Re: A K-4 CLASSROOM ADDITION BUILDING

ADDENDUM #2

April 20, 2017

Modifications or clarifications to original plans and specifications:

C1-FENCE

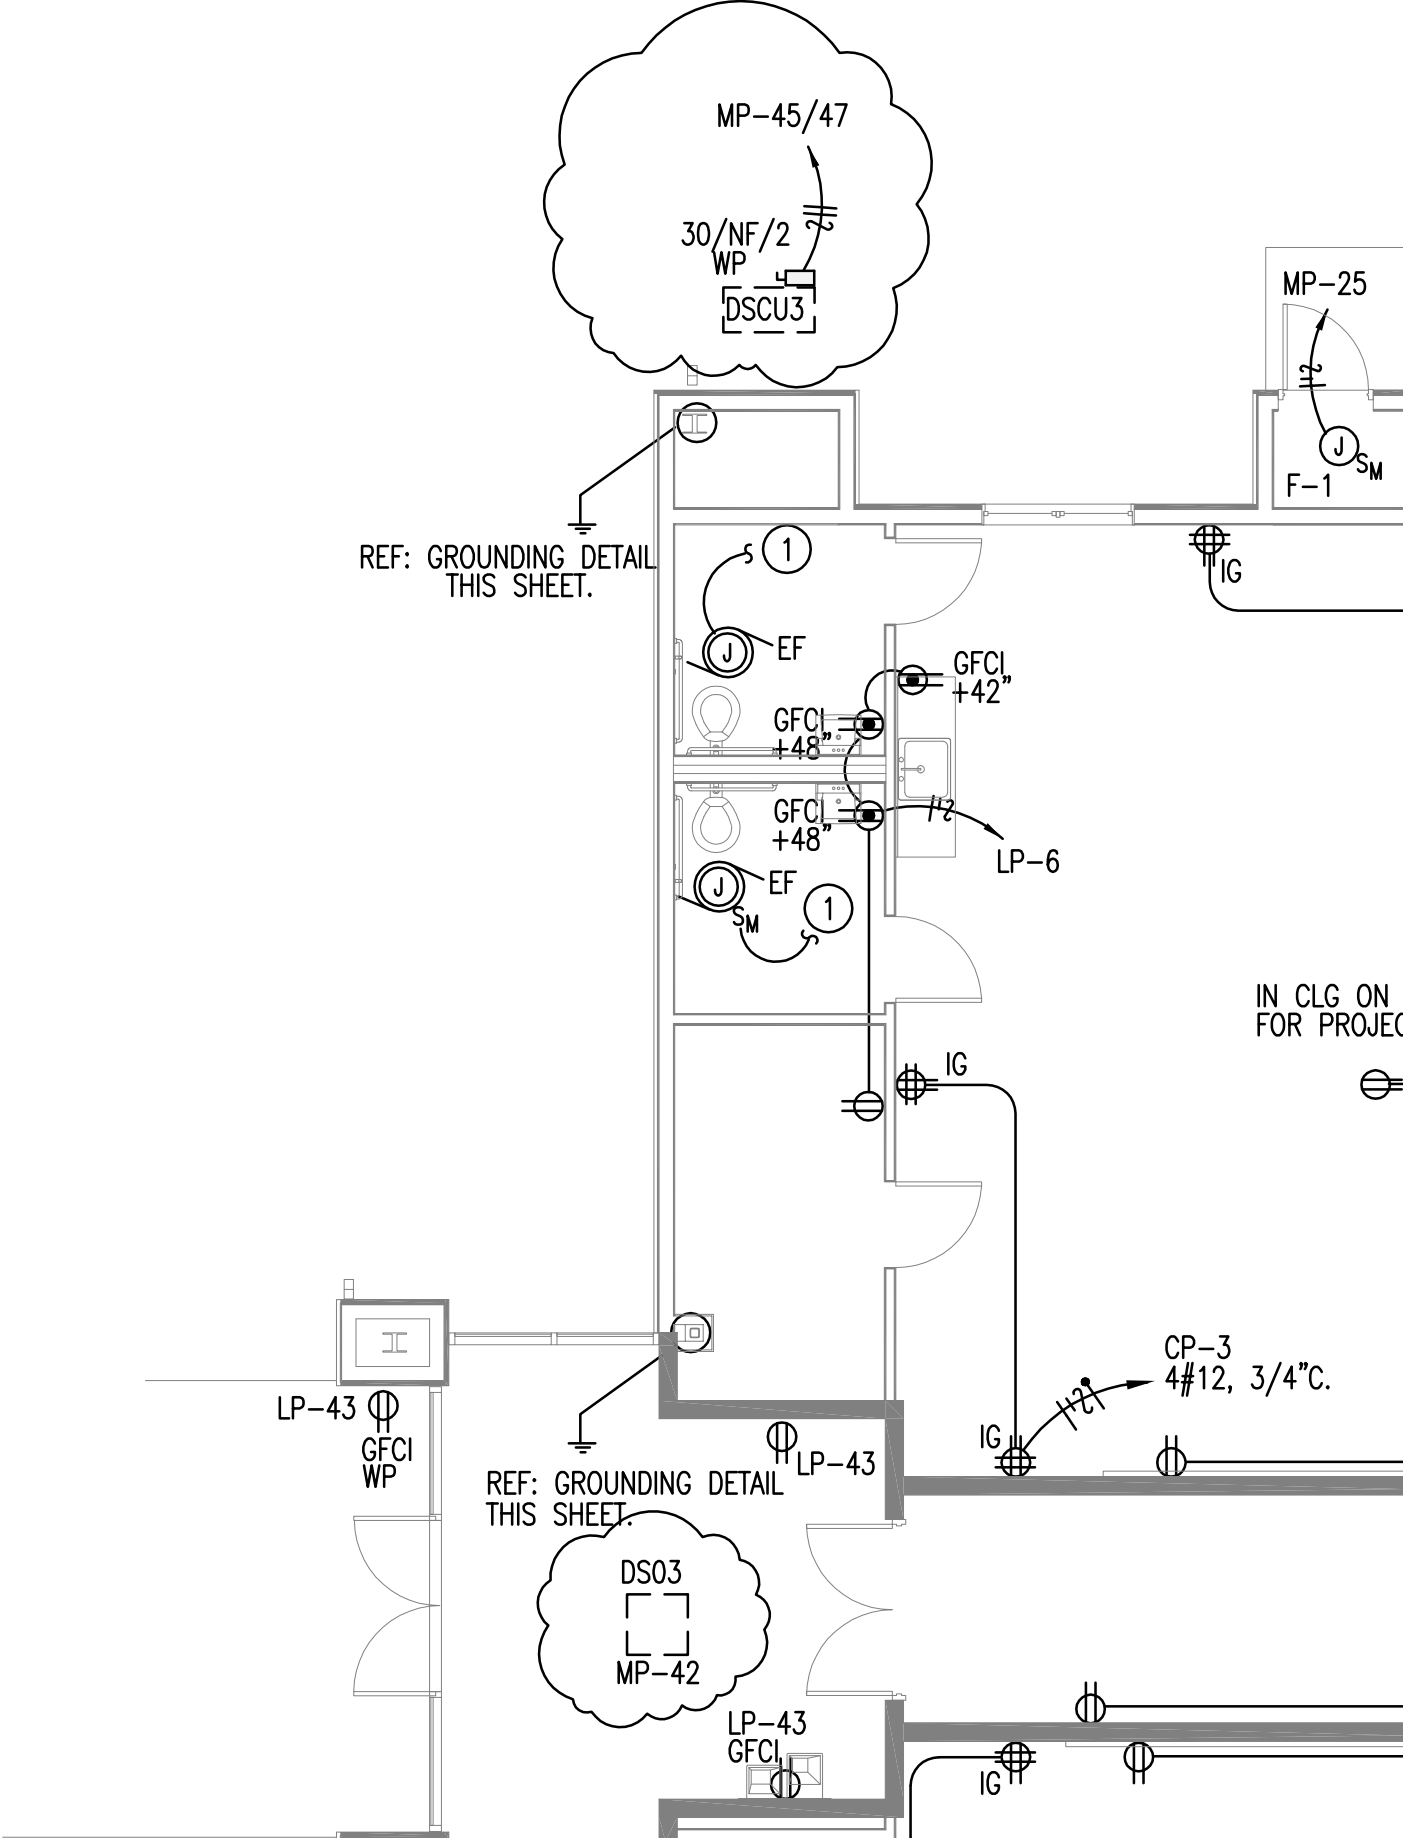
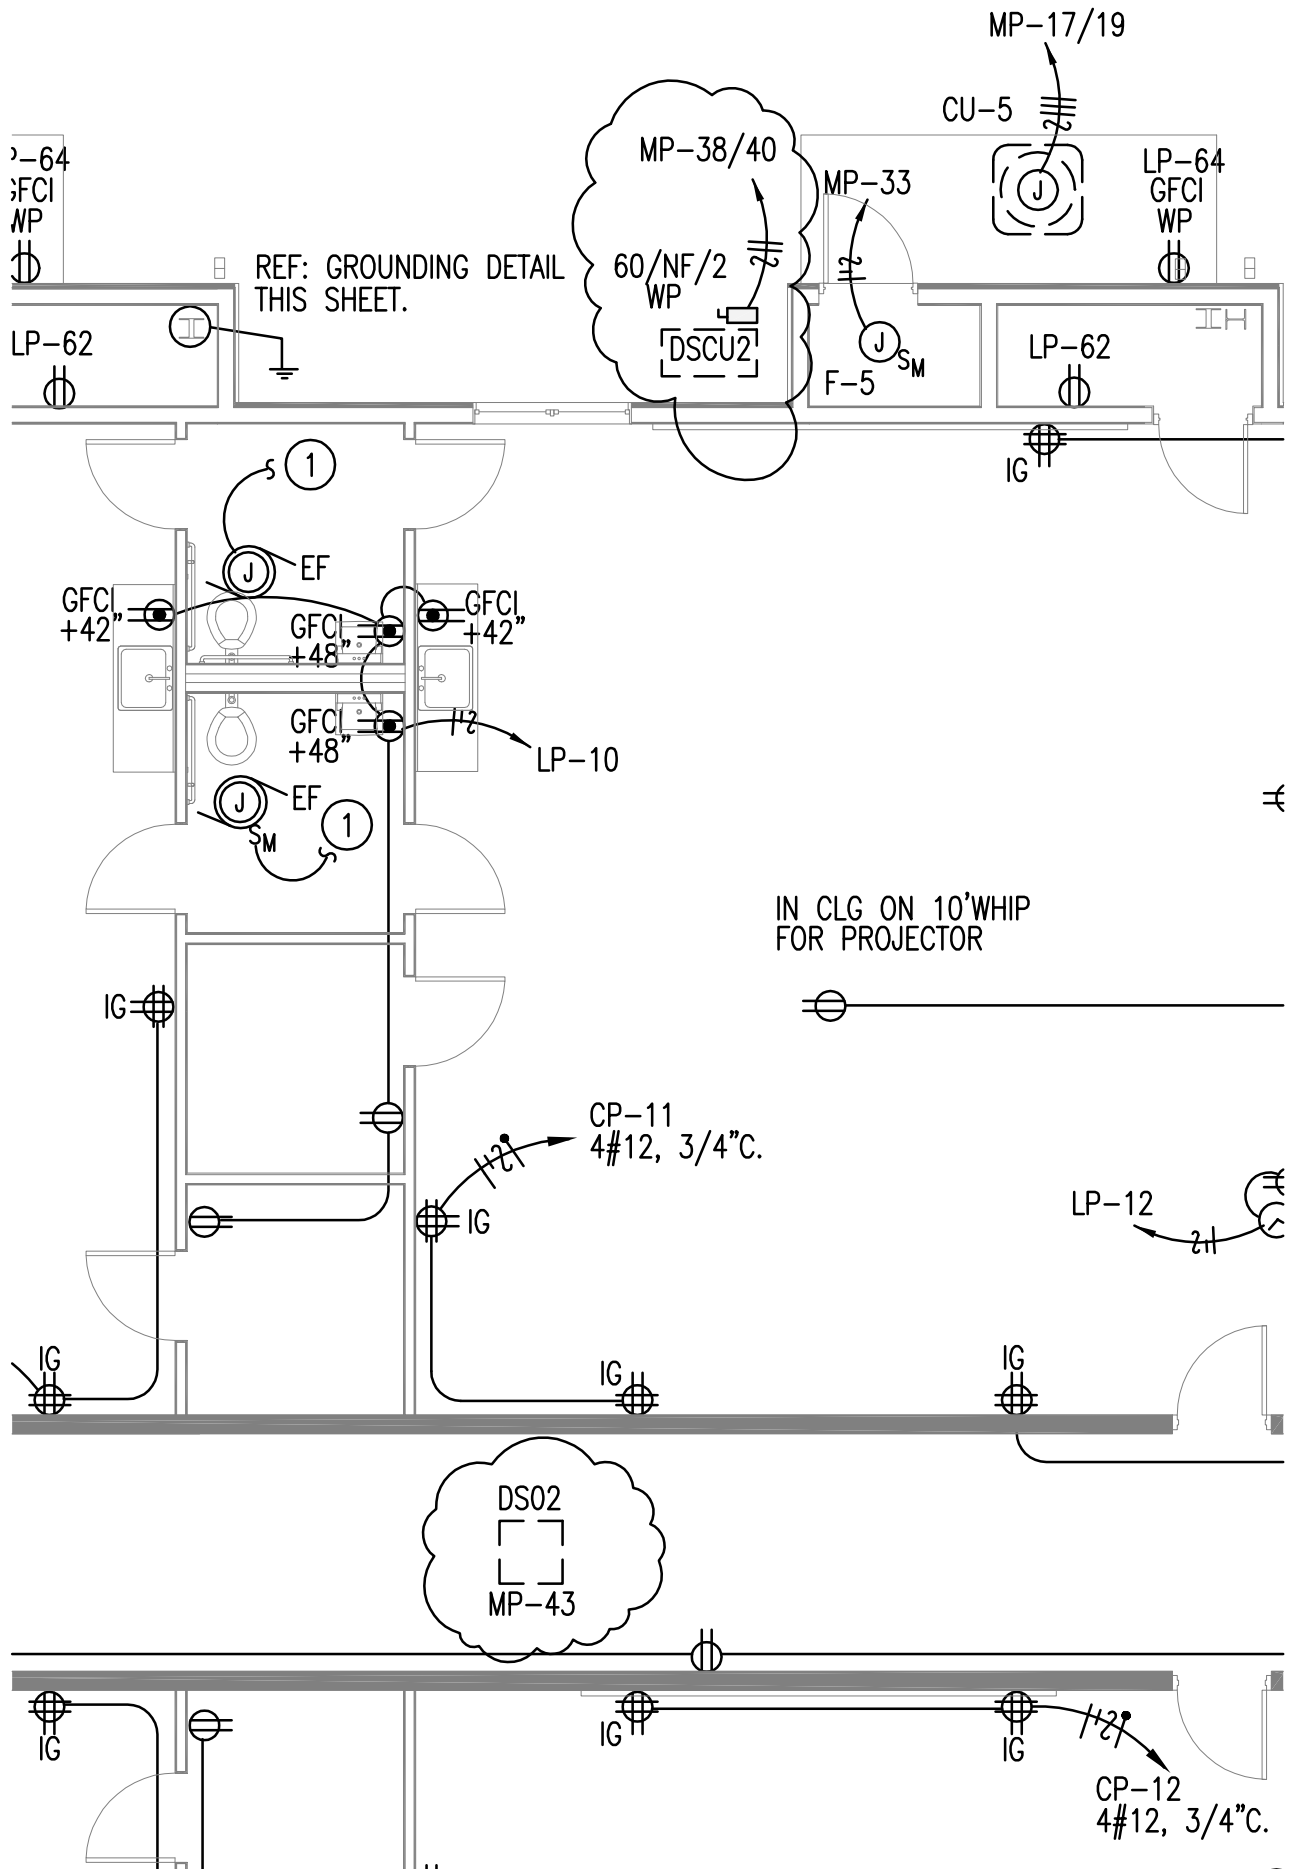
11. A temporary construction fence 6' high with a truck sized gate shall be required to be installed to secure the construction area from the immediate play area to the south of the construction area. See the attached map for the location and extent on the fence. The contractor shall determine the amount of security and fencing required at the north end of the construction area and shall take the necessary steps to protect students and others who might be using the adjacent school areas.in those areas.

FIRE ALARM RISER DIAGRAM

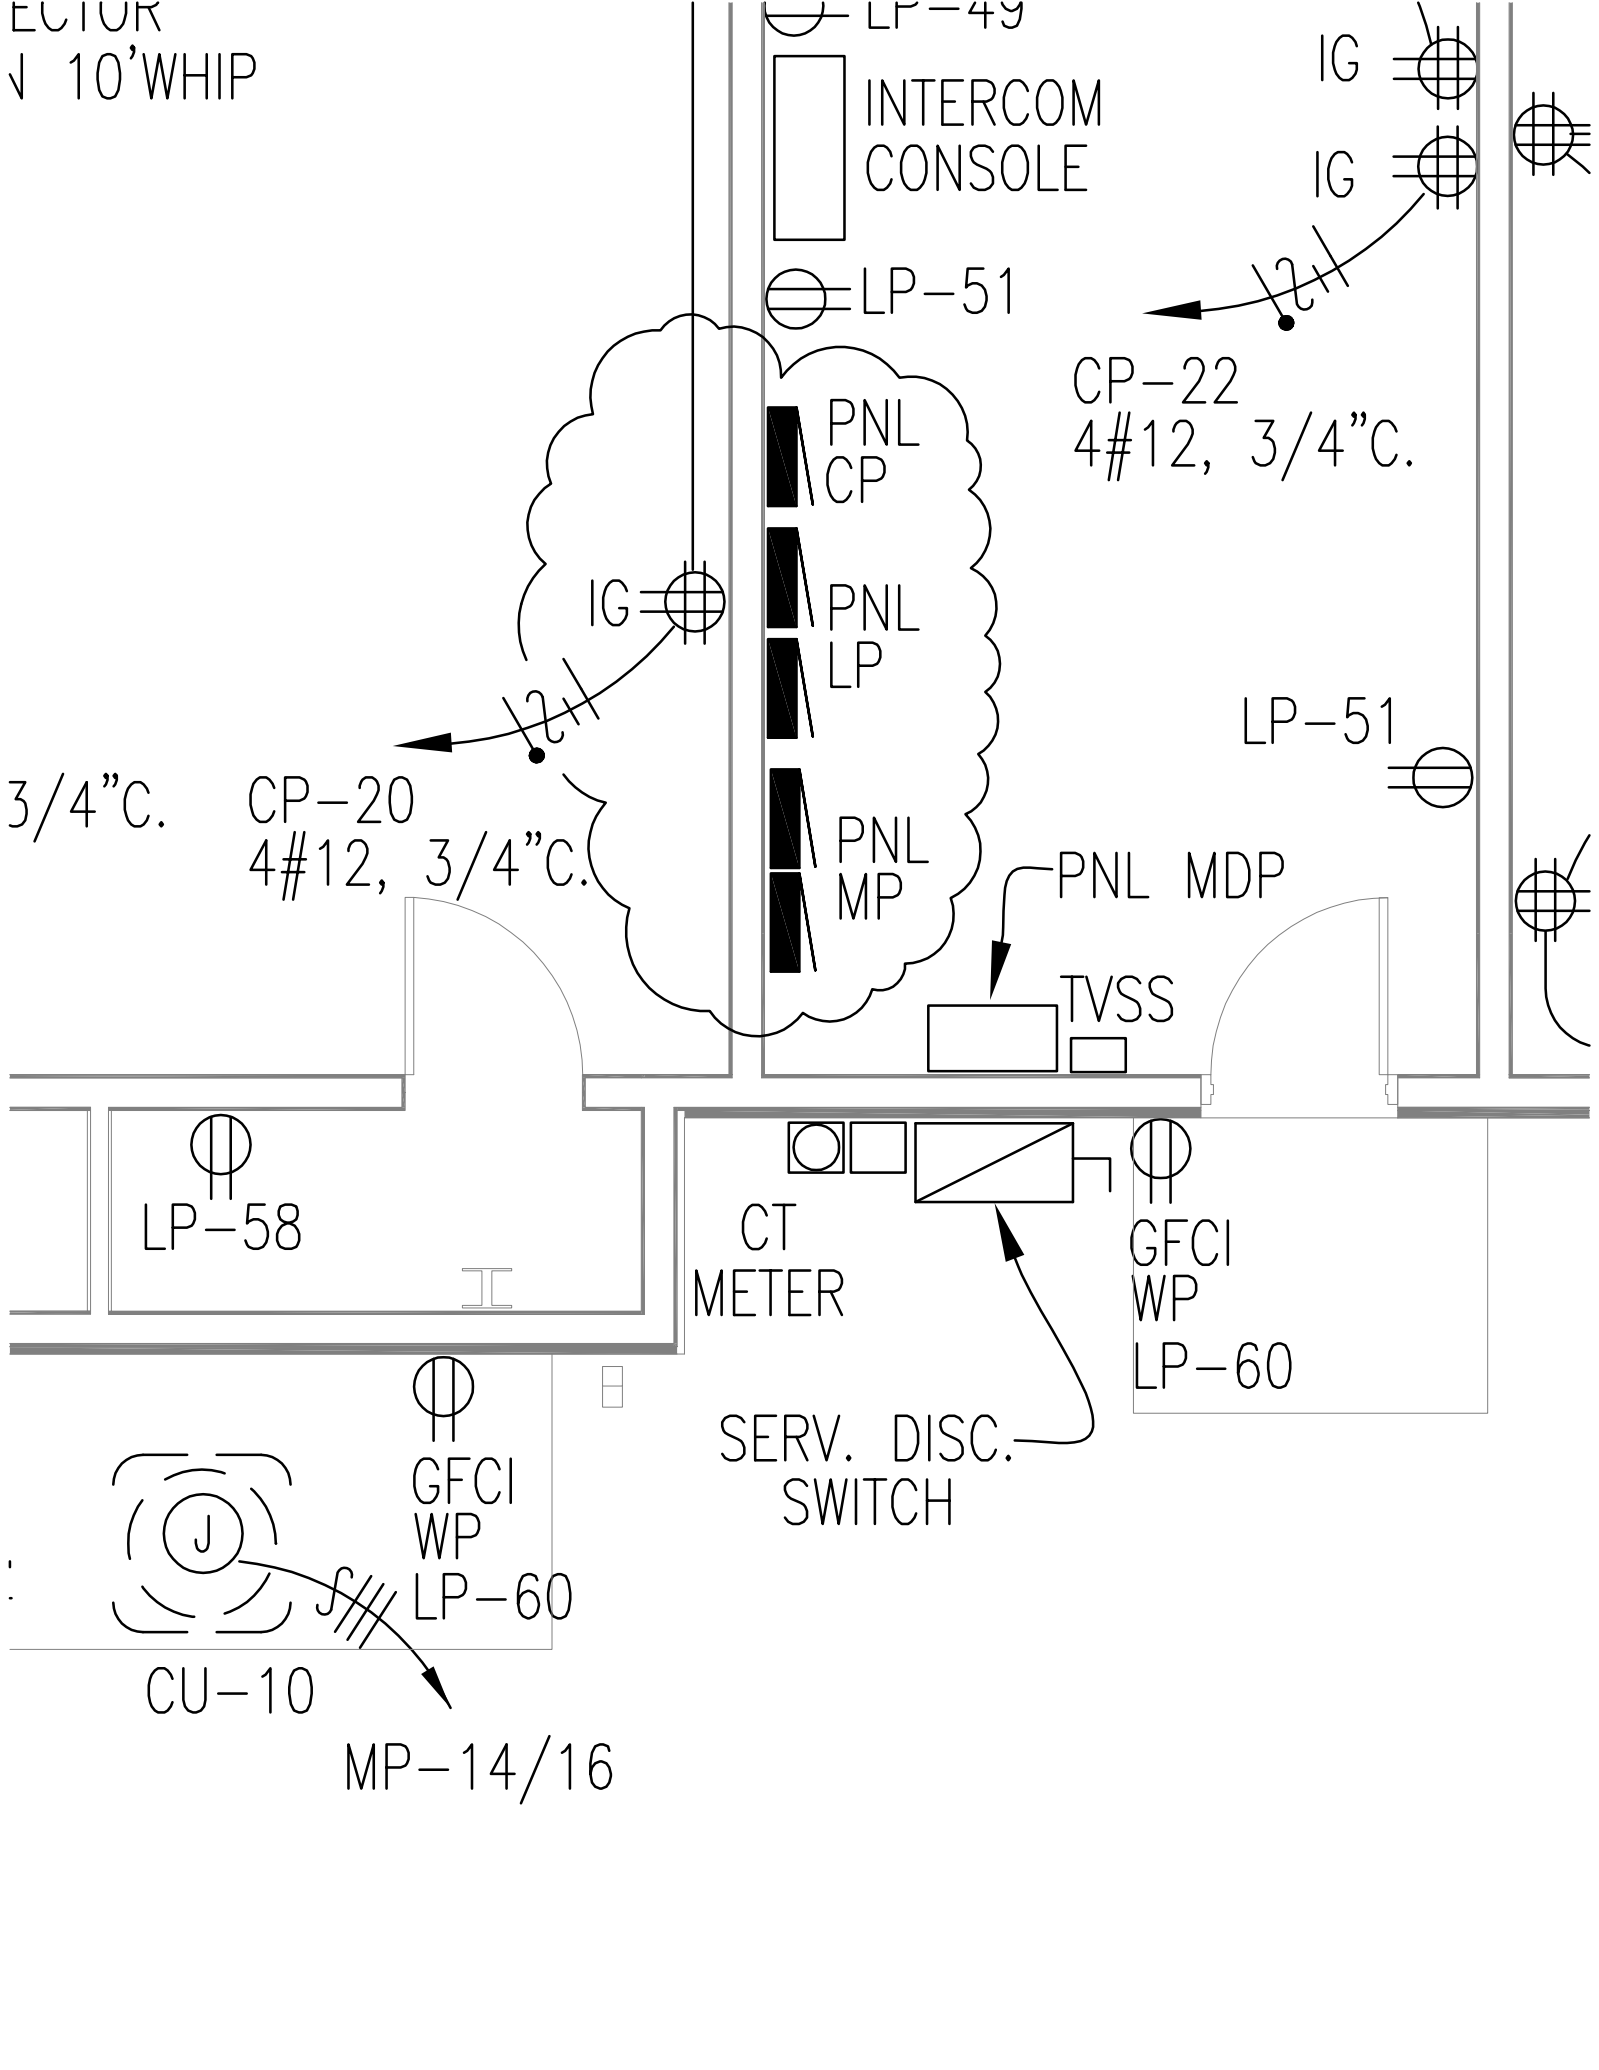
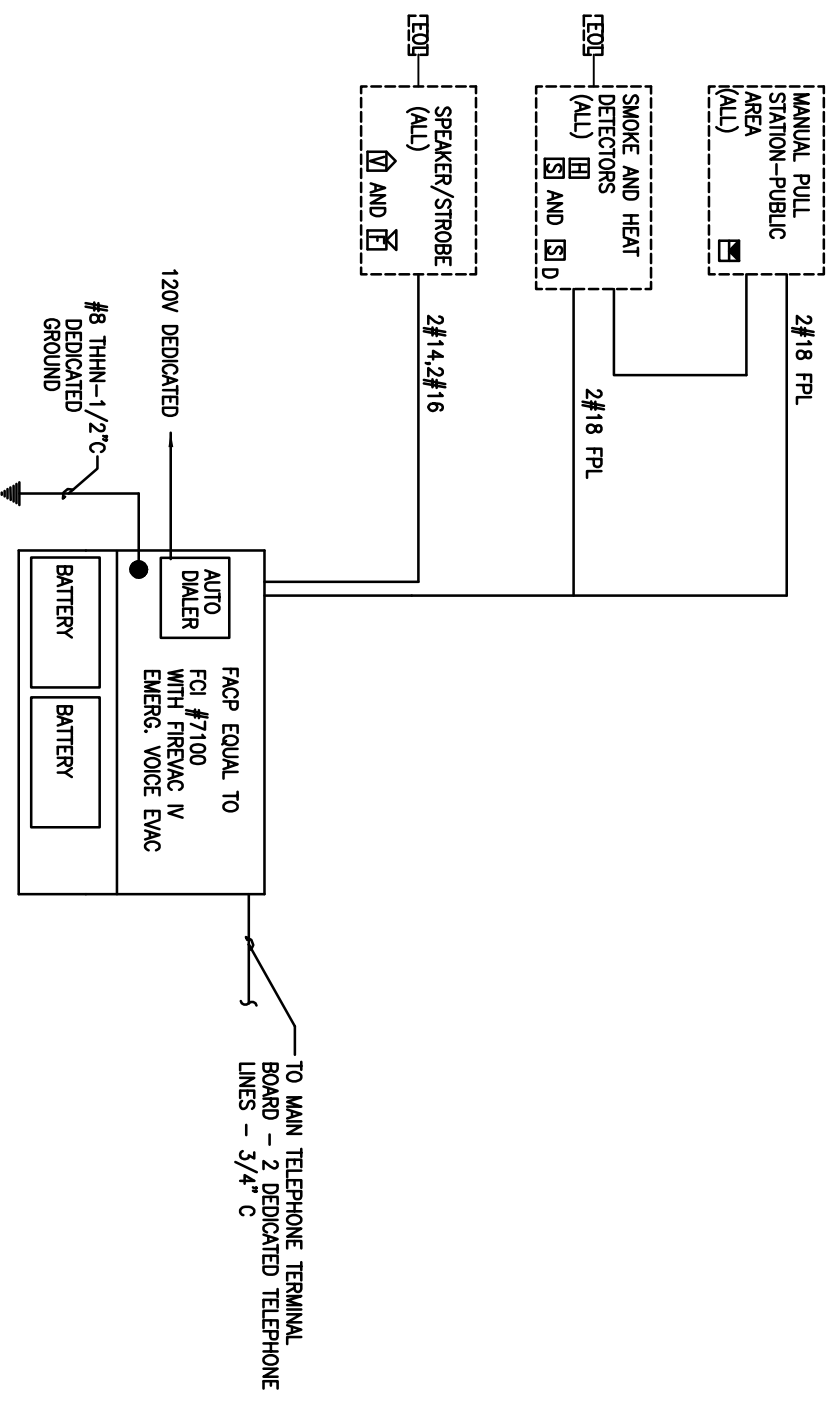
Sheet E5.1 – Added Fire Alarm Riser Diagram
